Service Note		
Product	Description:	Service note no.
VPD	Diodes mounting error	750 10 T007

The serial number range is: 109000 - 109499

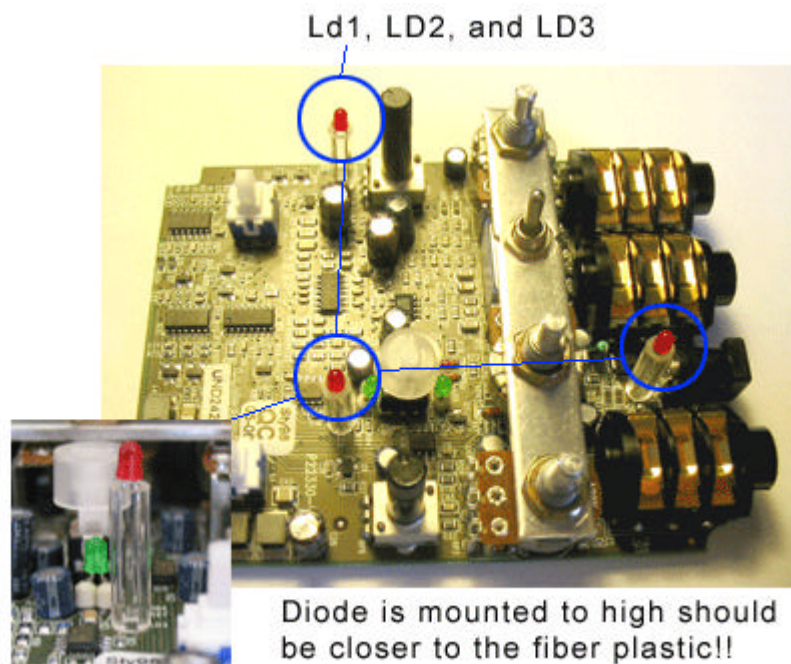
Symptoms: LD1, LD2 and LD3 Diodes mounted too high above the PCB print resulting in diodes braking down.

- 1) Un-mount the PCB from the VPD pedal.
- 2) Locate the diodes LD1, LD2 and LD3 fig.1.

Remedy: Lower diodes LD1,LD2 and LD3.

- 3) Lower and resolder these diodes.
- 4) Mount the VPD and start jamming.
